HOLDOVER

GRACELAND SUBDIVISION

Revised for the July 7, 2005 meeting:

DETAIL SITE PLAN

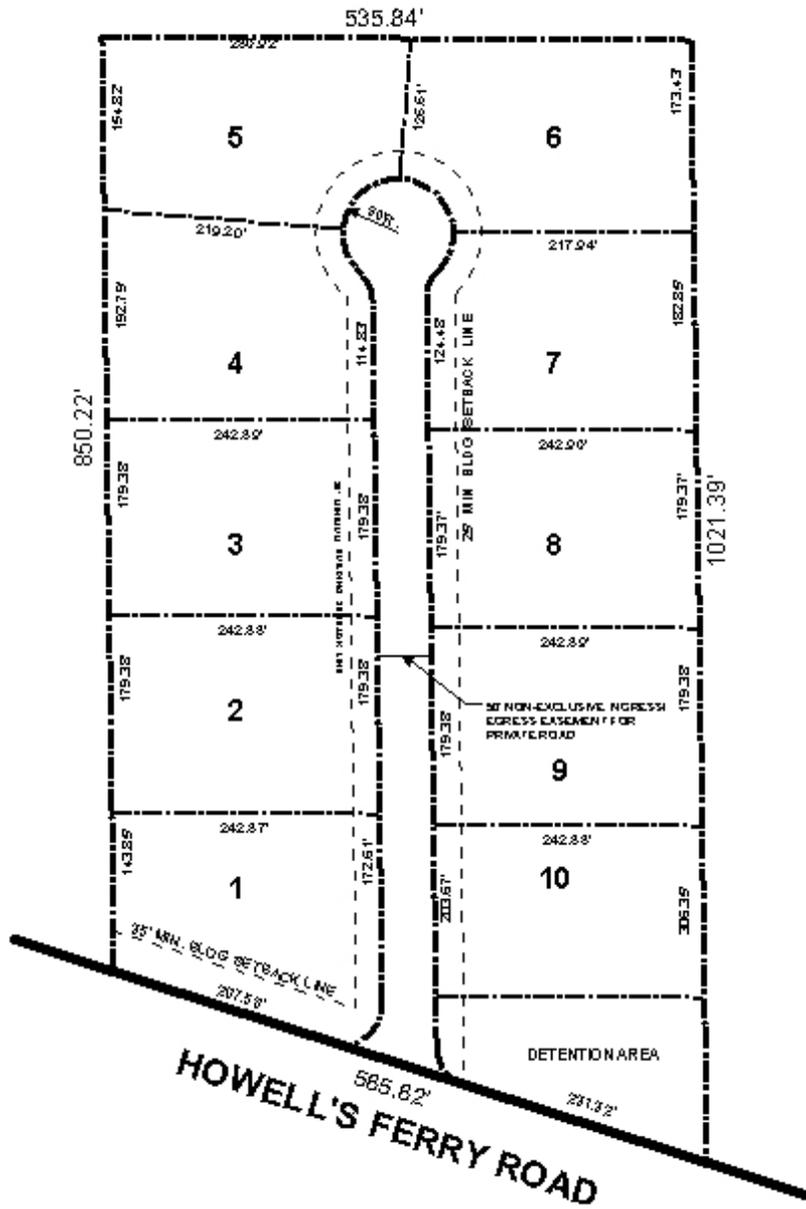
As Howells Ferry Road / Spring Hill Avenue - Ziegler Boulevard thoroughfare is a proposed major street, access management is a concern. A note should be placed on the Final Plat stating that lots 1 – 5 are denied direct access to Howells Ferry Road / Spring Hill Avenue - Ziegler Boulevard thoroughfare.

The private street is depicted as an easement on the plat. Section VIII.E.2.c. of the Subdivision Regulations require that private streets be provided as private rights-of-ways, rather than easements, to ensure accessibility to all properties that are to have access to the private street. Therefore if the subdivision is approved, the note on the plat stating “50’ *NON-EXCLUSIVE INGRESS/EGRESS EASEMENT FOR PRIVATE ROAD*” should be revised to reflect the Subdivision Regulations’ requirements. Furthermore, the proposed private street must be built to the minimum standards listed in the Section.

It should also be noted that Section VIII.E.1.b. states “*Subdivisions in which Private Streets are allowed shall not be adjacent to large undeveloped potentially landlocked tracts of property where a street stub would be required.*” The site, in fact, abuts approximately 275 acres of land to the north that is currently landlocked. Access to the landlocked area from the north is limited due to the presence of Crooked Creek and its associated floodplains and wetlands. Thus the denial of the private street and the provision of a public street with a street stub to the north is recommended.

A note should also be placed on the plat, if approved, stating that maintenance of the detention basin common area is the responsibility of the subdivision’s homeowners association.

Based upon the proceeding, the plat is recommended for Tentative Approval, subject to the following conditions: 1) the denial of the private street request, with the street being replaced by a dedicated public street built to Mobile County standards, and with a street stub to the north; 2) the dedication of 10 feet of right-of-way along Howells Ferry Road, including that contained within the proposed detention area; 3) the provision of a minimum rear yard setback of 58 feet for lots 1-5; 4) placement of a note on the Final Plat stating that lots 1 – 5 are denied direct access to Howells Ferry Road and the Spring Hill Avenue - Ziegler Boulevard thoroughfare / new connector to Moffett Road; 5) placement of a note on the Final Plat stating that any lots which are developed commercially and adjoin residentially developed property must provide a buffer, in compliance with Section V.A.7. of the Subdivision Regulations; and 6) placement of a

note on the Final Plat stating that maintenance of the detention basin common area is the responsibility of the subdivision's homeowners association.
